Ground Floor Strategy

Consented Scheme

Revised Scheme

Revised Scheme - Tenth to Twelfth Floor Plan

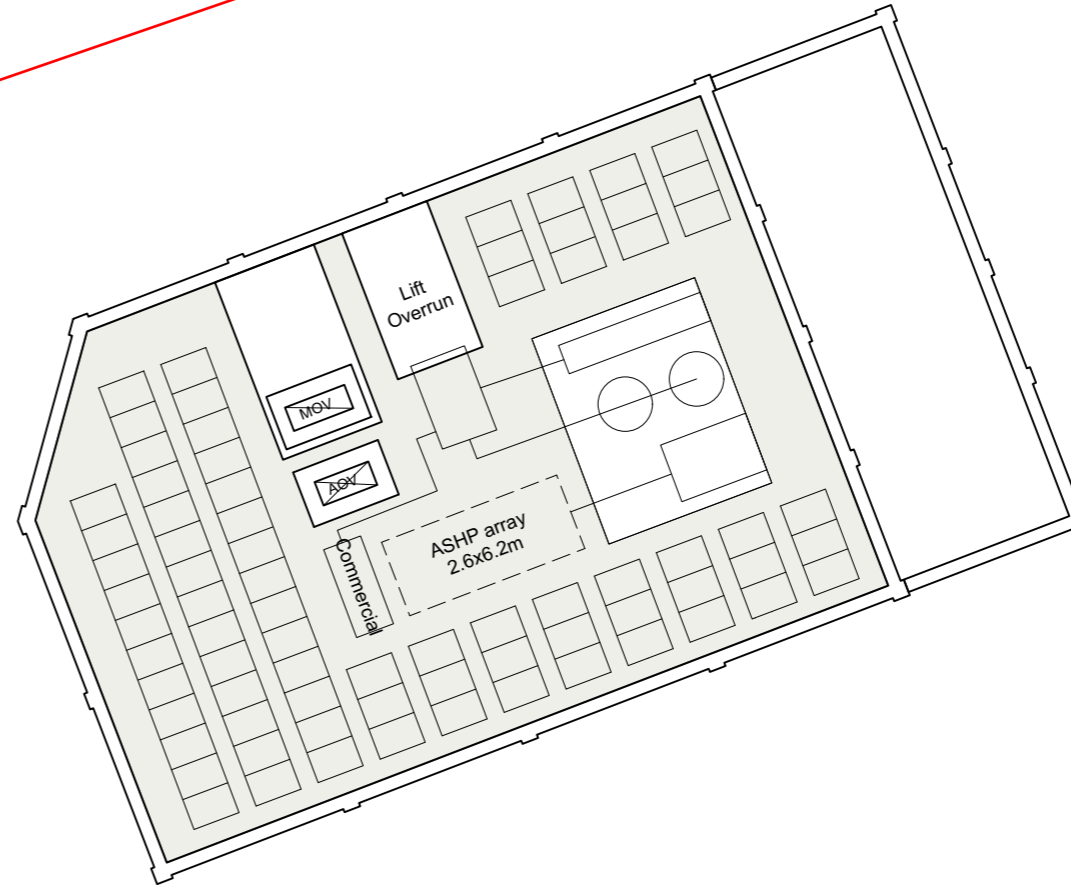
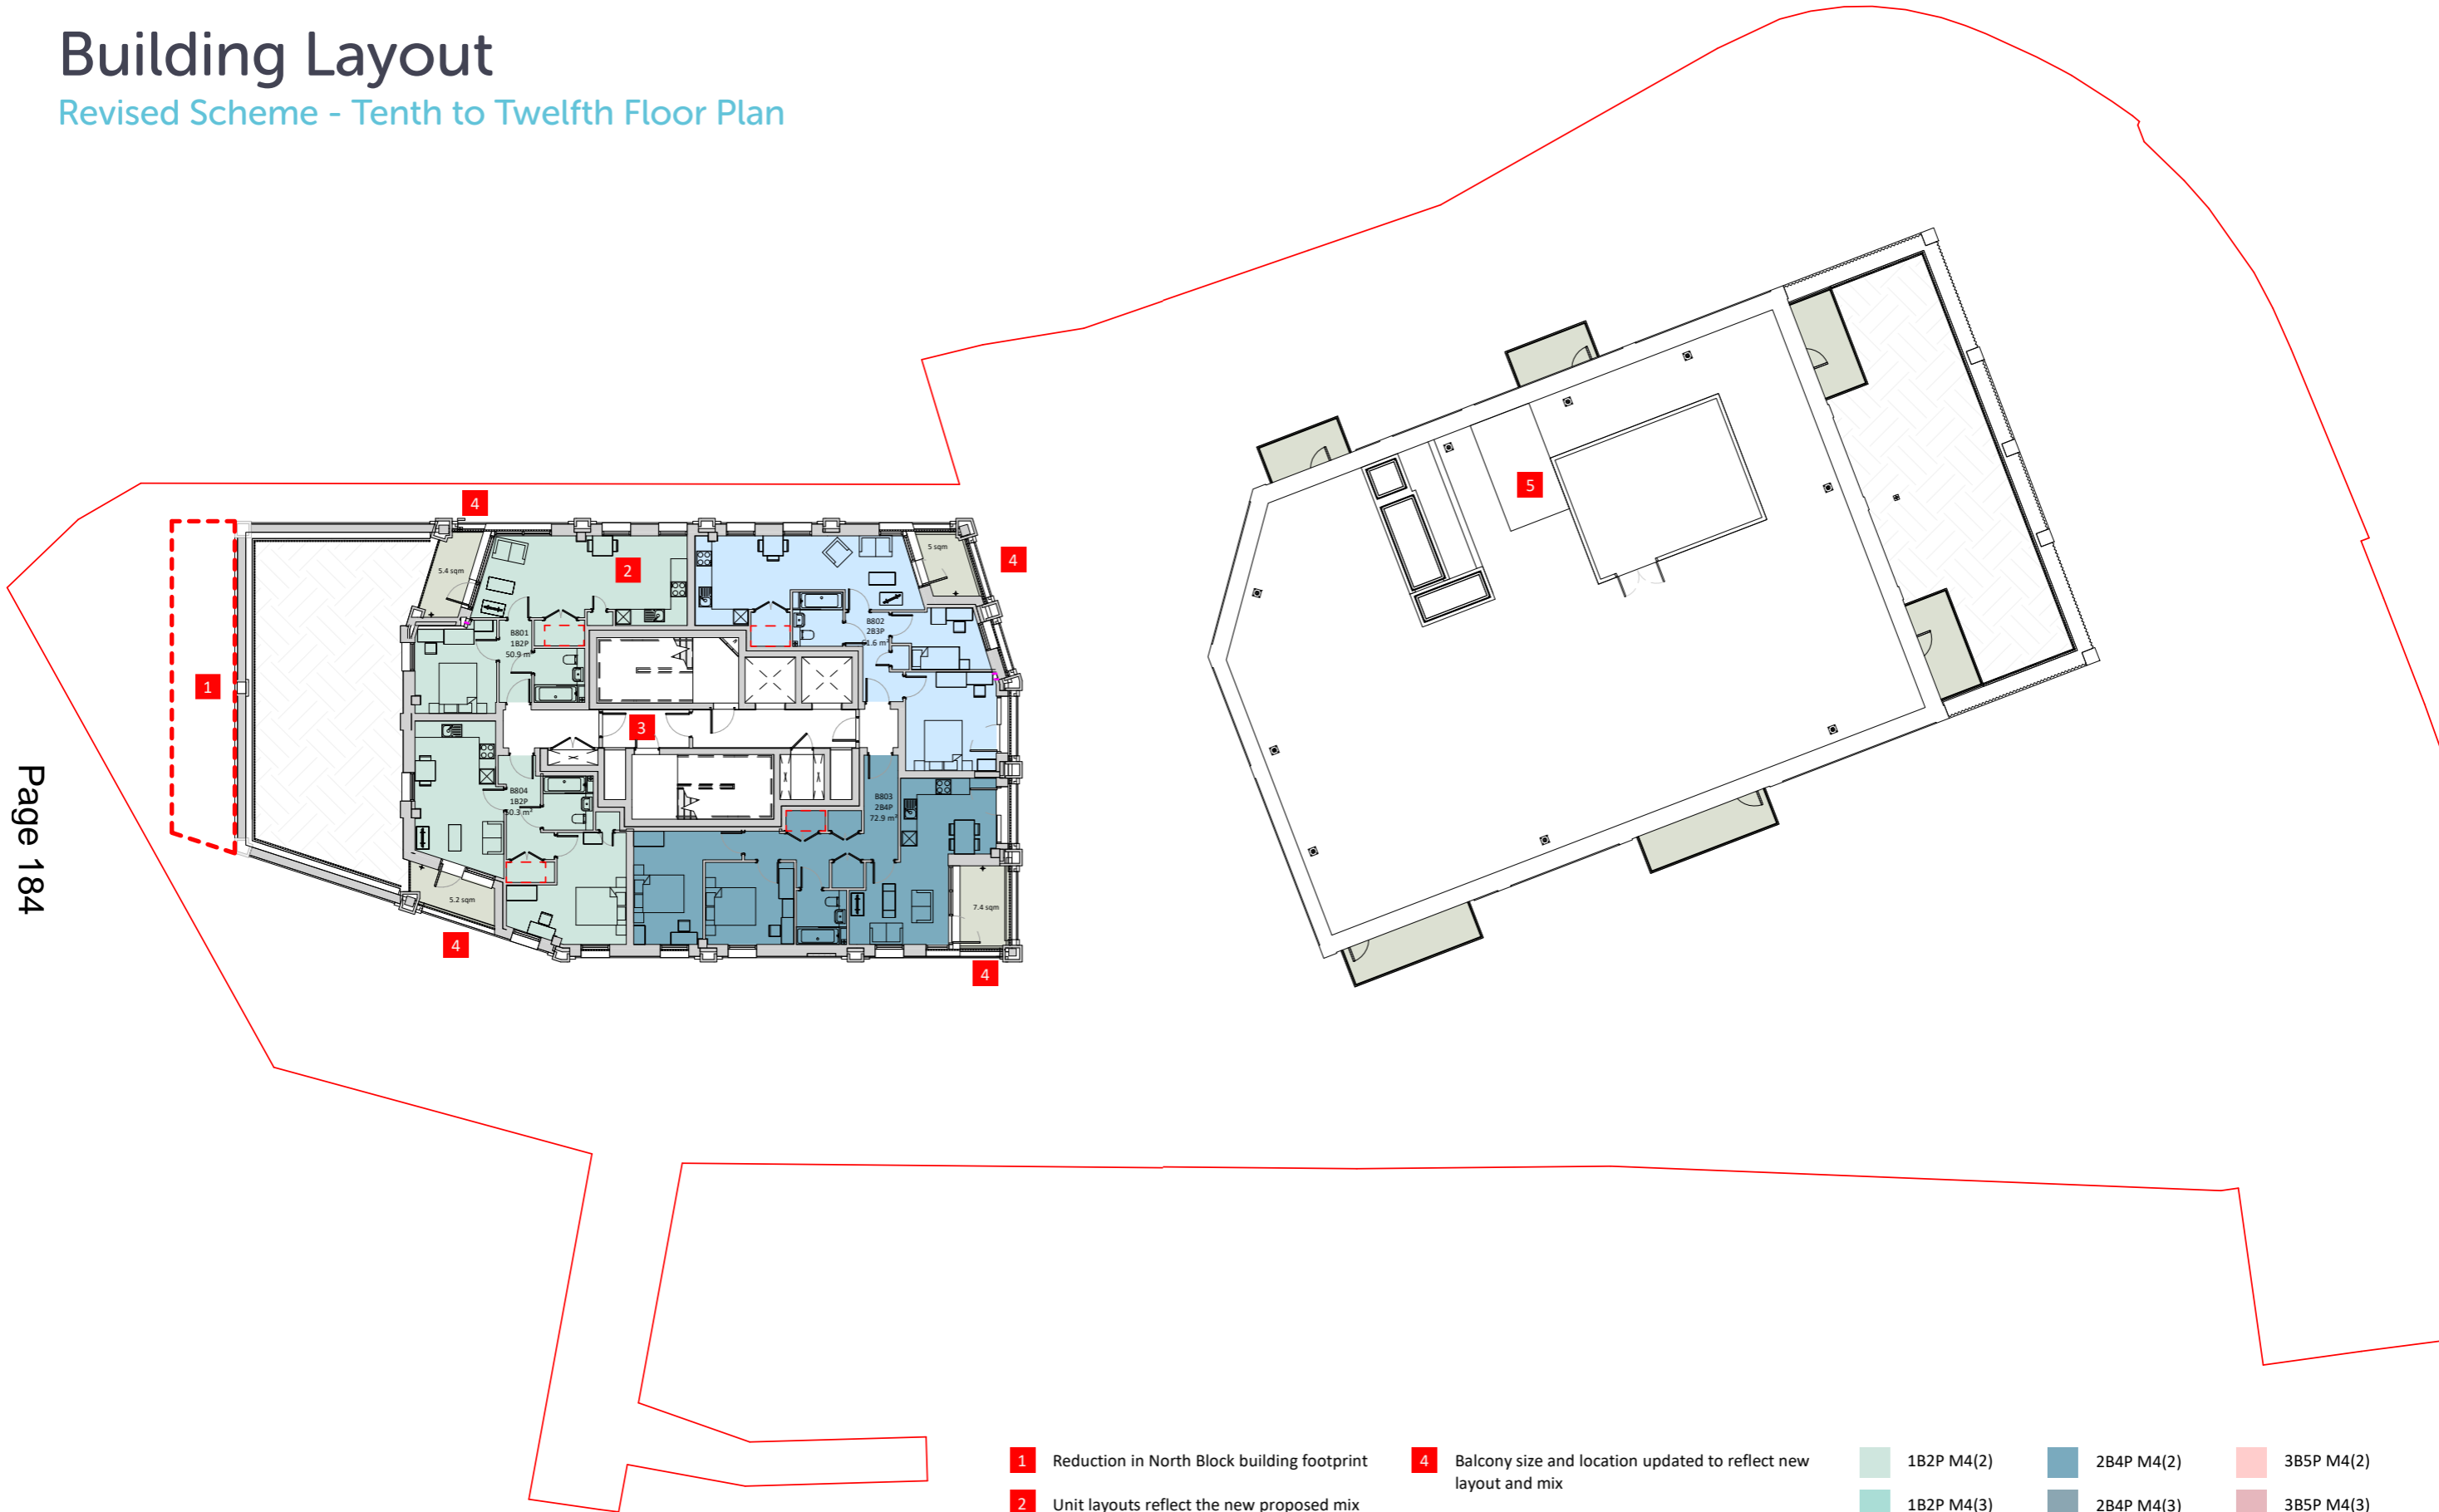
- 1** Reduction in North Block building footprint
- 2** Unit layouts reflect the new proposed mix
- 3** Revised core to accommodate secondary escape stair an additional vents and risers

- 4** Balcony size and location updated to reflect new layout and mix
- 5** Roof Level Plant moved in accordance with below core shift

Revised Scheme - Block A (South Block), East Elevation

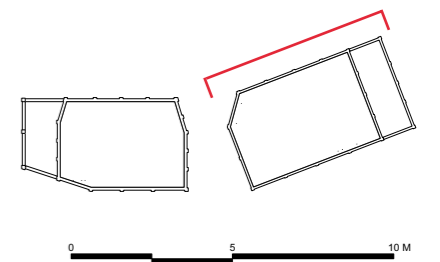
- 1 Introduction of additional decorative window blanks
- 2 Adjustments made to the setting out of brick piers
- 3 Adjustments made to the setting out of windows
- 4 Adjustments made to the setting out and widths of balconies

Revised Scheme - Block A (South Block), South Elevation

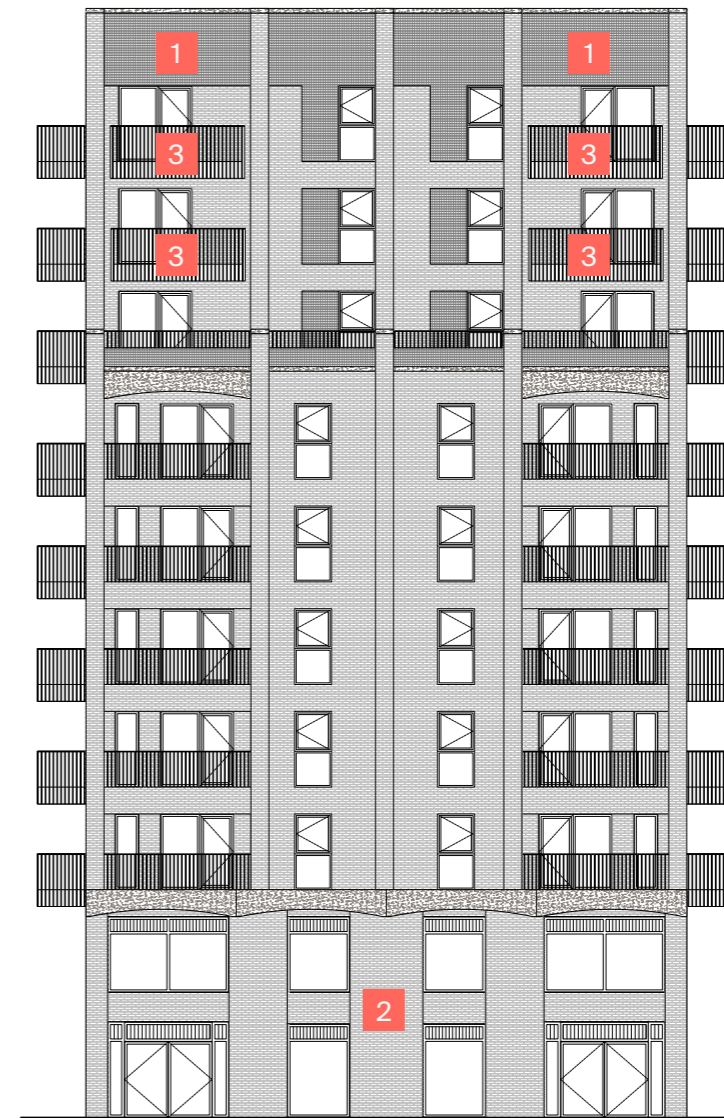
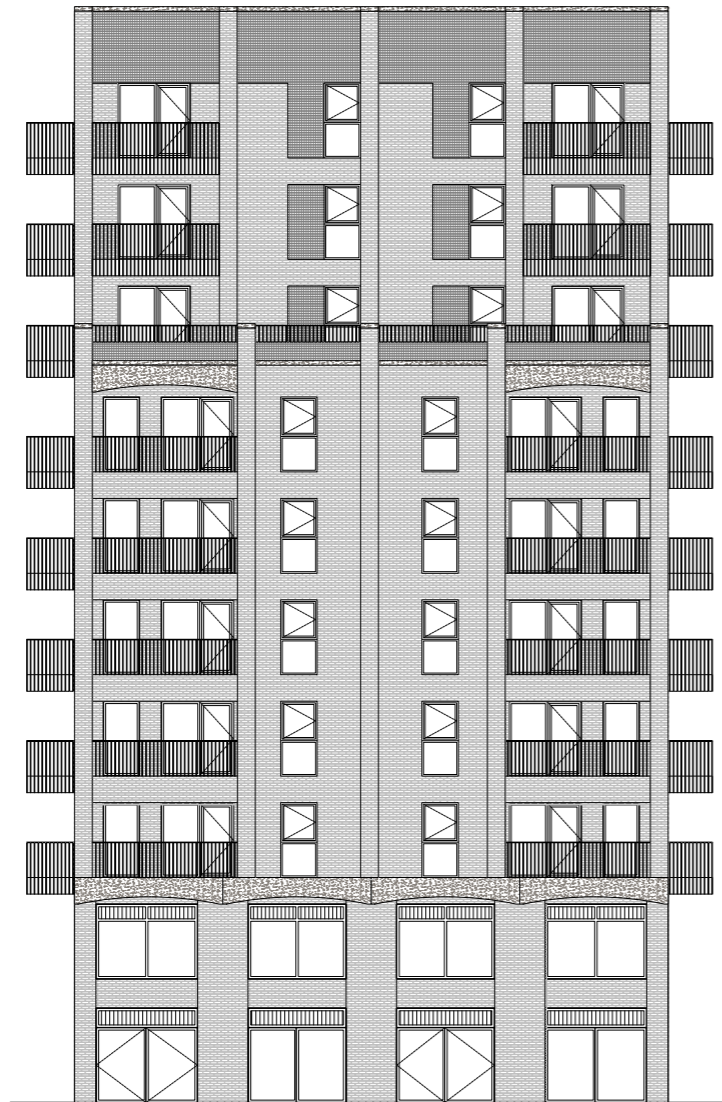
- 1 Adjustments made to the setting out of brick piers
- 2 Adjustments made to the setting out of windows
- 3 Adjustments made to the setting out and widths of balconies

Revised Scheme - Block A (South Block), West Elevation

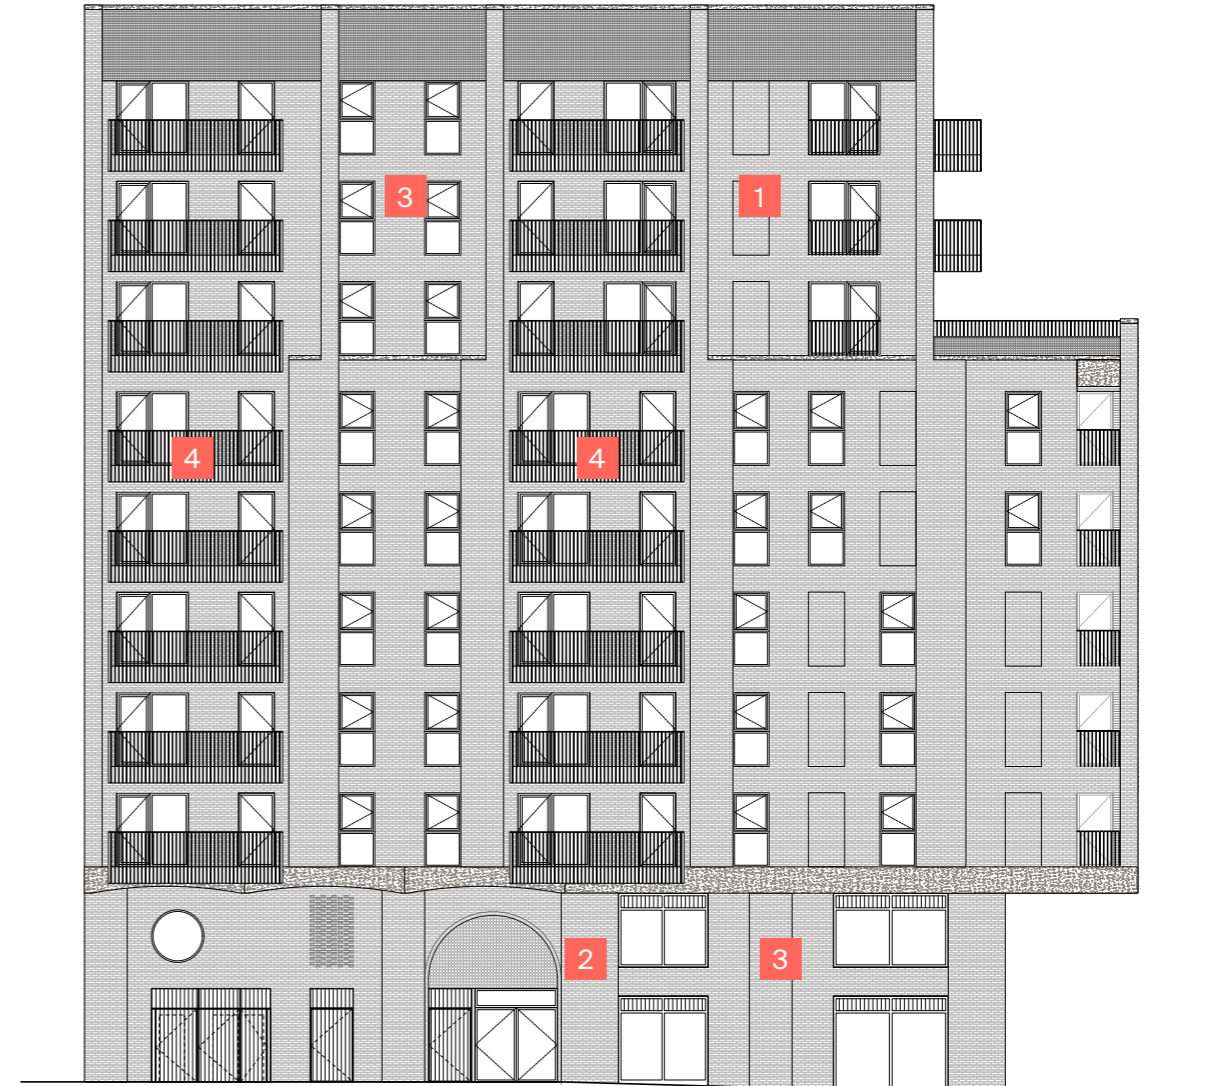
- 1 Introduction of additional decorative window blanks
- 2 Adjustments made to the setting out of brick piers
- 3 Adjustments made to the setting out of windows
- 4 Adjustments made to the setting out and widths of balconies

Revised Scheme - Block B (North Block), East Elevation

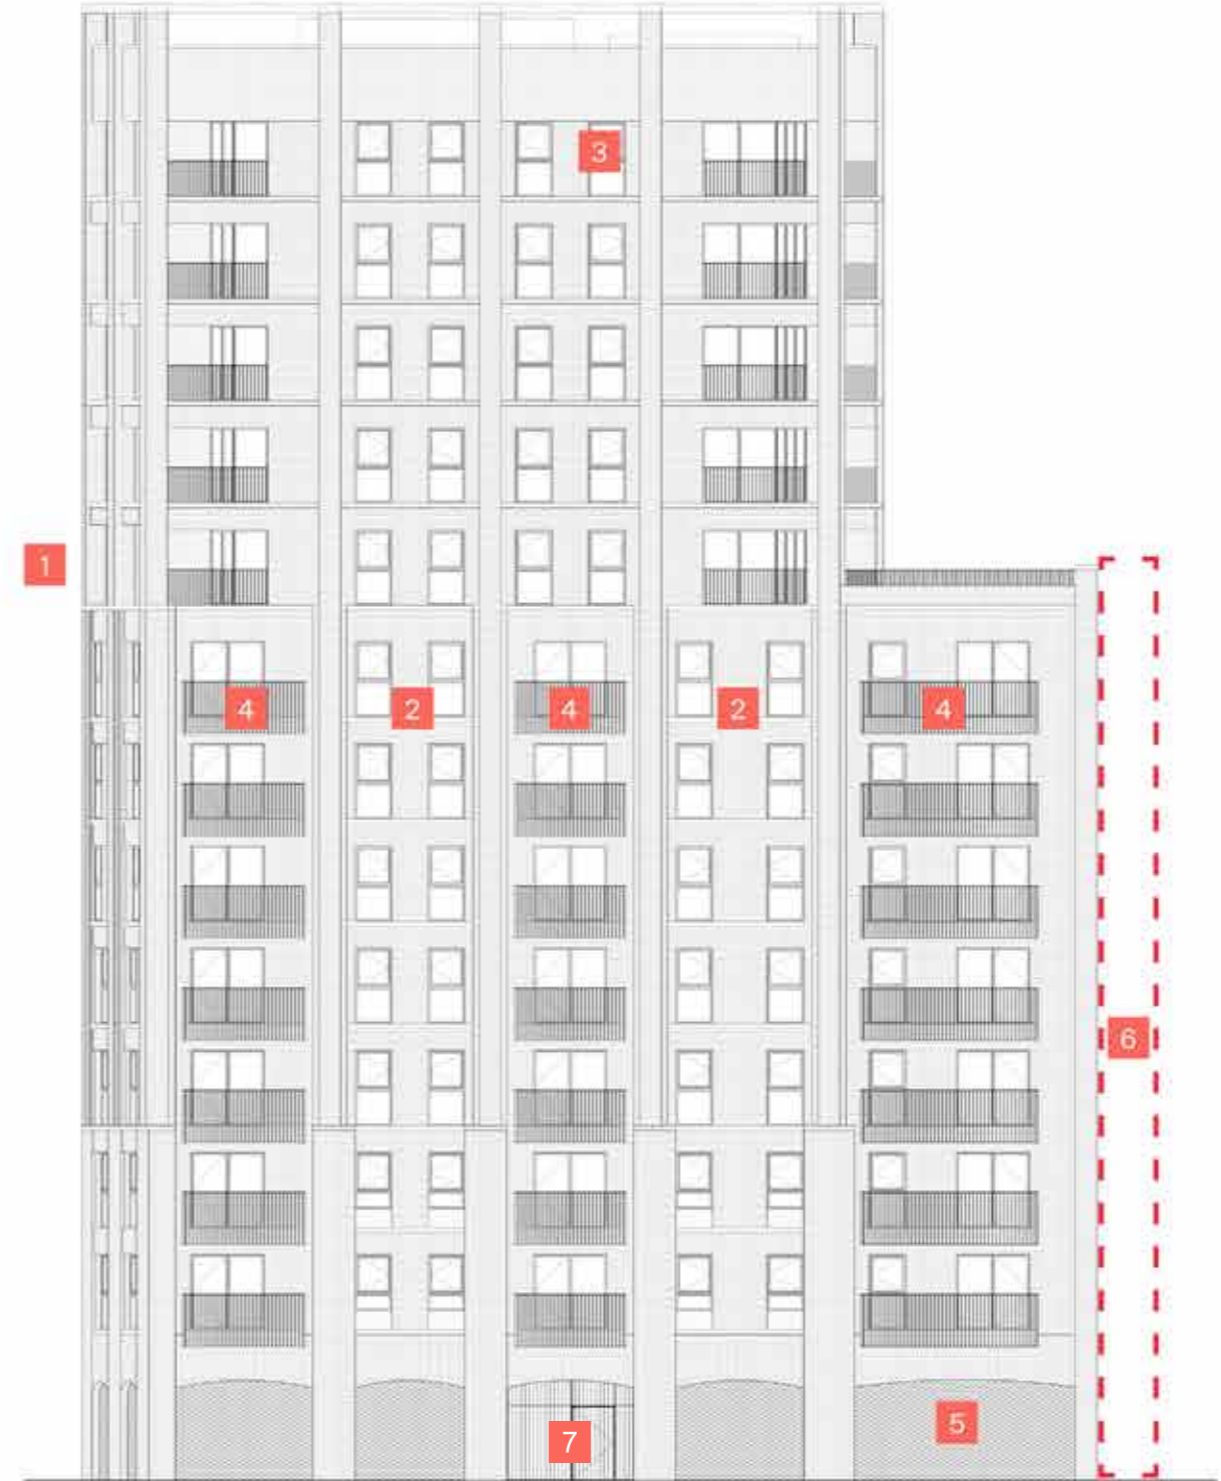
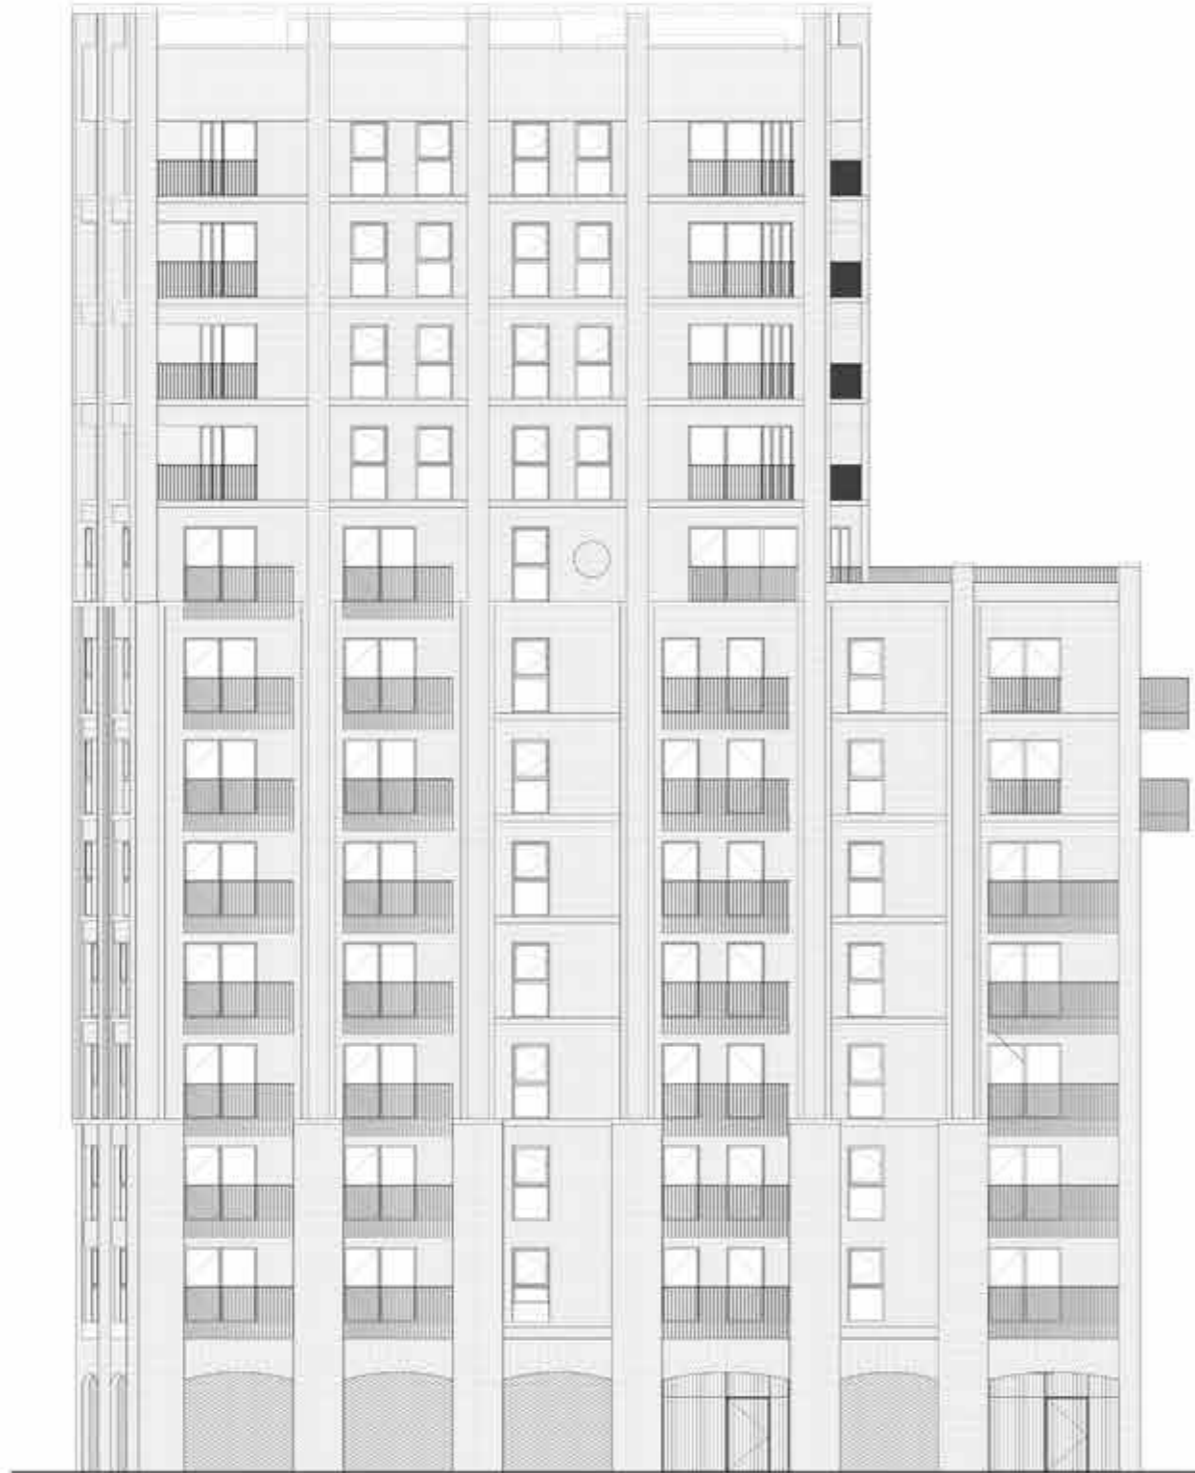
- 1** Elevation of eighth floor has been revised to match the floors above
- 2** Introduction of new windows
- 3** Adjustments made to the setting out of windows

- 5** Introduction of new perforated brickwork
- 6** Dashed red line indicates reduced massing
- 7** Minor ground floor amendments following addition of second staircas
